City of Surrey  
**PLANNING & DEVELOPMENT REPORT**

File: 7911-0186-00

Planning Report Date: November 7, 2011

in order to permit the development of a 1,859 sq.m. (20,000 sq.ft.) industrial building.

VIEW ALONG 76th AVENUE

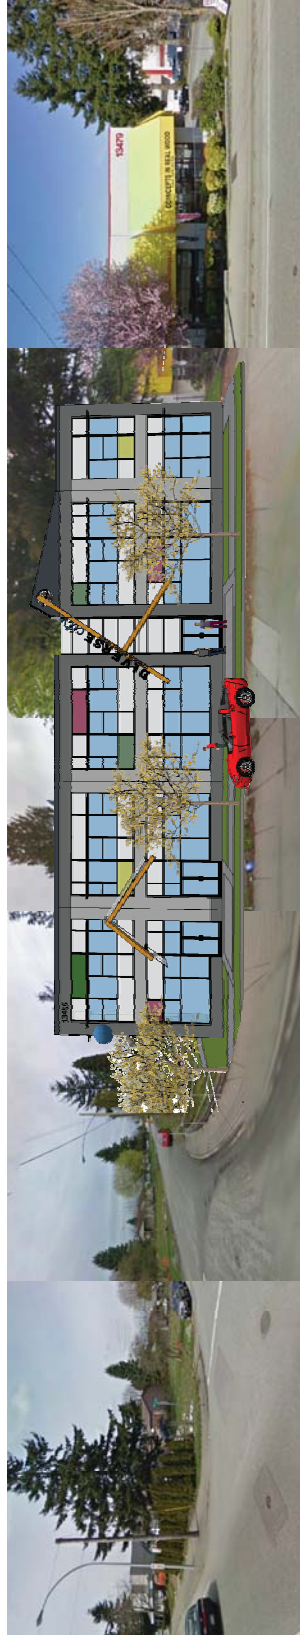
- Give the elevation one more kick:
  - Good start, nice glass concept
  - Consider east wall. **The east elevation is broken up with reveal lines in a pattern to exactly match the overall play of solid and openings on the west elevation. Also, paint colours are proposed to accentuate the play of 'solid' and 'void' space.**

- Continue the banding around onto the east elevation with reveals [wall will be exposed above existing building]. **East elevation is broken up with reveal lines in a pattern to exactly match the overall play of solid and openings on the west elevation. Also, paint colours are proposed to accentuate the play of 'solid' and 'void' space.**

- Signage beam is a great idea. It seems a bit small and not part of the elevations which are overwhelming it. [Revise sign structure to integrate more with the building design, e.g., raise the parapet at one side to support the sign.] **The lettering is greatly increased in size and runs up the main support strut. The upstand parapet is increased in size as suggested.**

DRAWING TITLE: LANDSCAPE PLAN

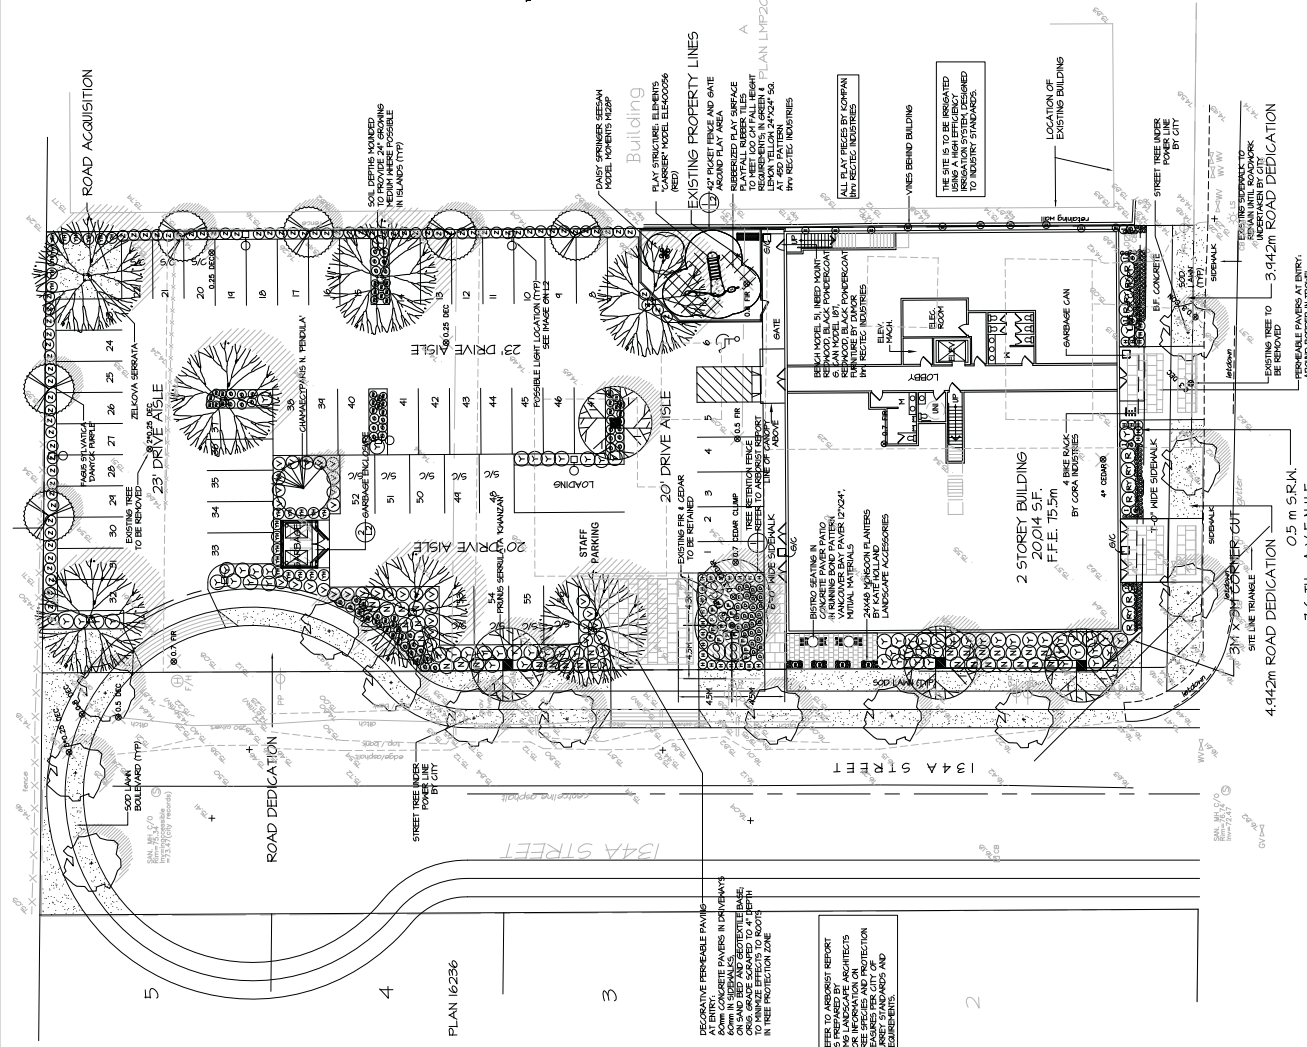
- Landscape is well done.
- Consider opportunities for outdoor picnic tables. Bistro seating is noted on the landscape plans.
- Garbage enclosures a long distance from building. This is the preferred location by the user of the building, as it keeps smells and possible mess away from the building. The garbage enclosure is mainly accessed by janitorial staff after hours.

- Provide unit paving or colour concrete in pedestrian walkways, particularly at plaza areas and locations assigned for outdoor seating. Pavers are added in the pedestrian walkways, in the added plaza, at the front entries and between the old and new sidewalks.

- Consider the use of permeable paving and/or provide rain gardens to intercept surface runoff from parking lot. Permeable paving at the site entry drive is expanded in area. Water will be directed to this area as much as possible.

- Consider reorganizing the parking stall layout to enable a second through access in place of the proposed garbage enclosure location. This would help to improve circulation as the current scheme does not provide for a hammerhead for the parking spaces immediately adjacent to the garbage enclosure. The garbage enclosure could be relocated to an enlarged island perhaps adjacent to the children's play area. The current layout is one that achieves the greatest amount of parking in the space available, and is preferred by the end user. We have labelled the dead end aisle "Staff Parking", and those words are to be on the asphalt surface for all to see as they enter the site. Visitors will only be using the through aisle. The garbage enclosure is in the preferred location by the user of the building, as it keeps smells and possible mess away from the building. The garbage enclosure is mainly accessed by janitorial staff after hours.
